Subject: Class II Permissive Change

FCC ID: BEJLC10SB
Date of Grant: 02/12/2016

We, LG Electronics Inc., apply for the C2PC change according with FCC Rule Part §2.1043.

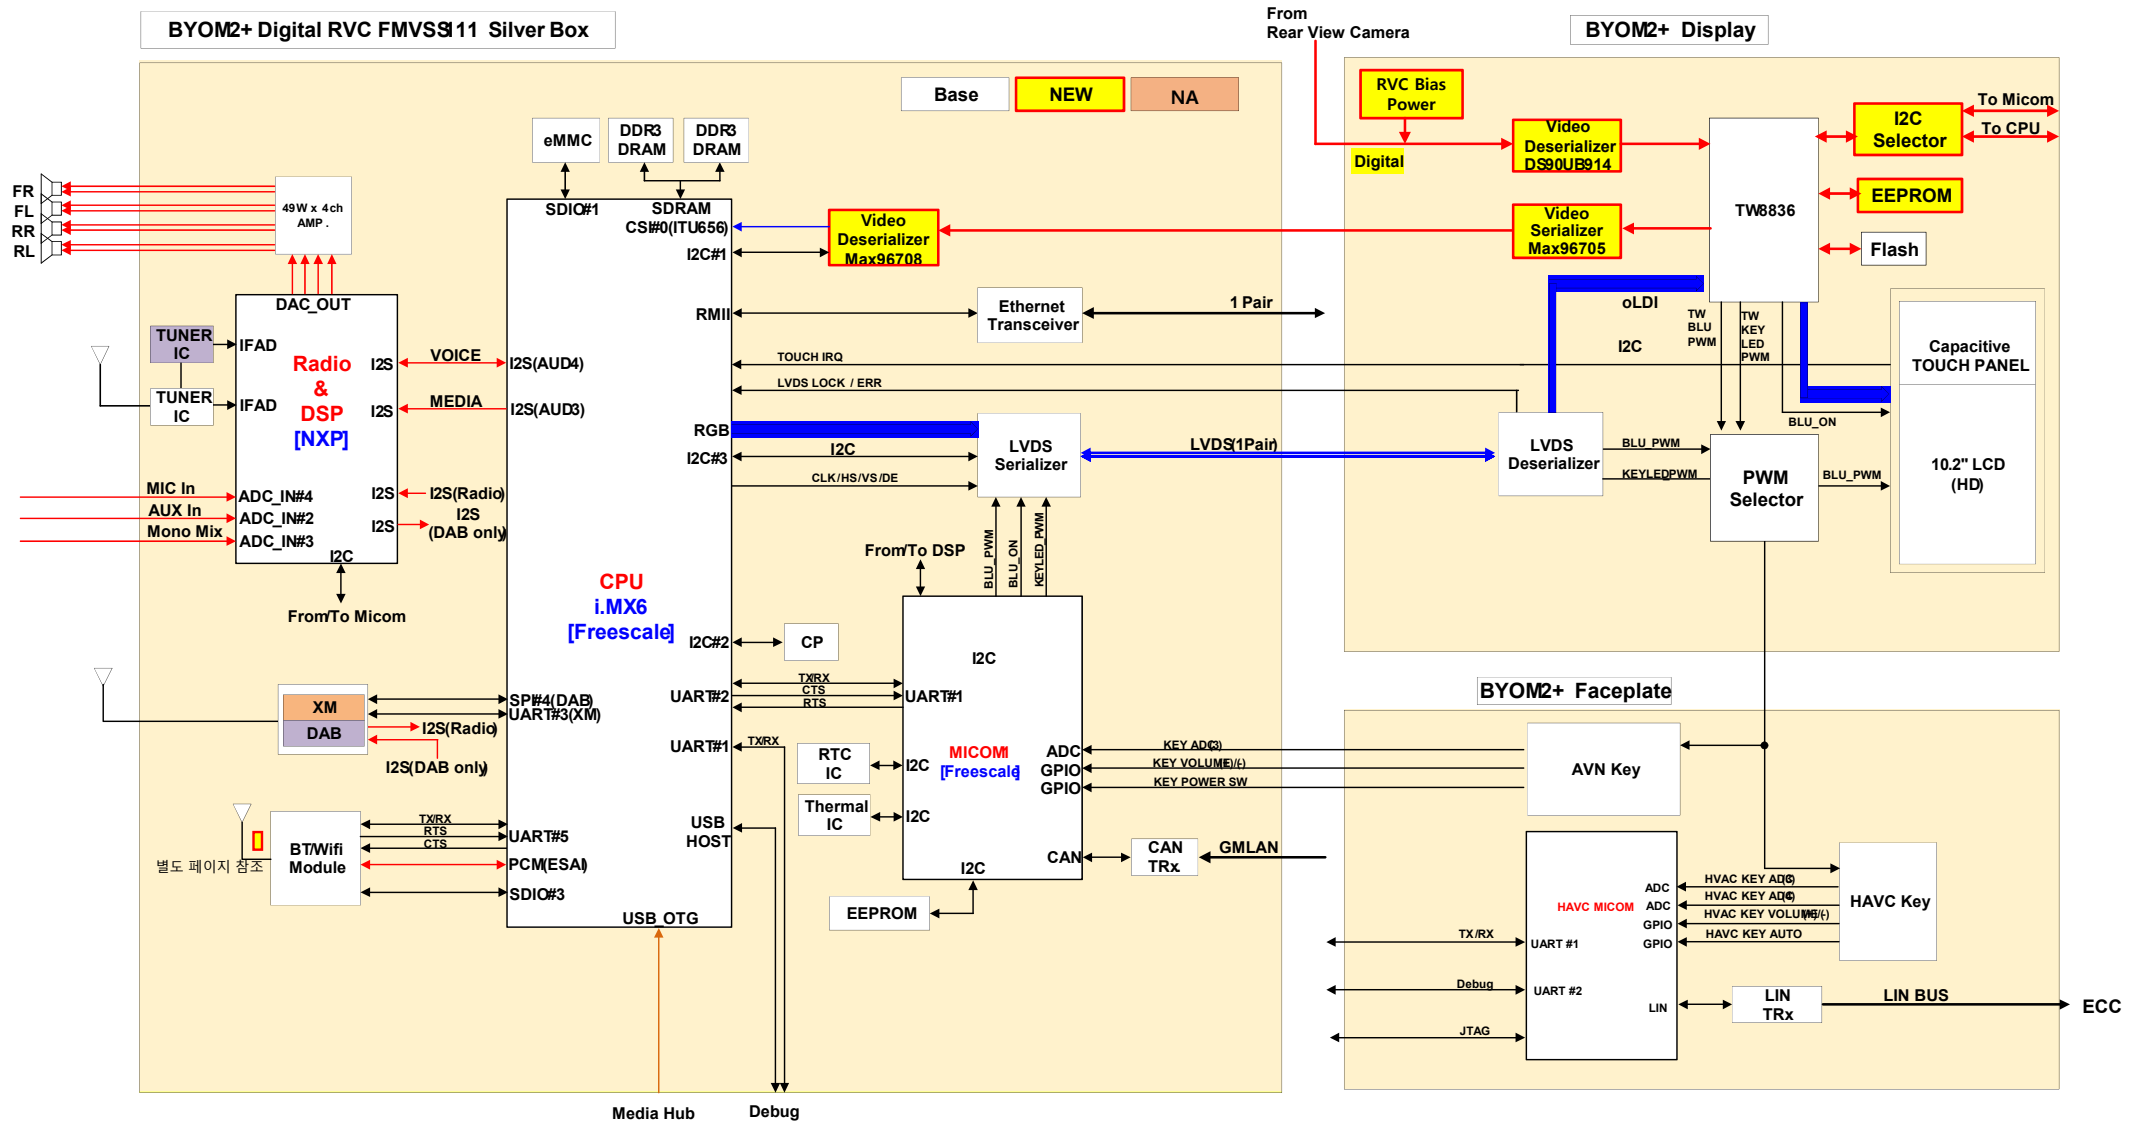
#Change 2-1)

- To change the Rear Camera from analog to digital, some of circuit is added.

#Change 2-2)
- Adding inductor on the line of the Antenna
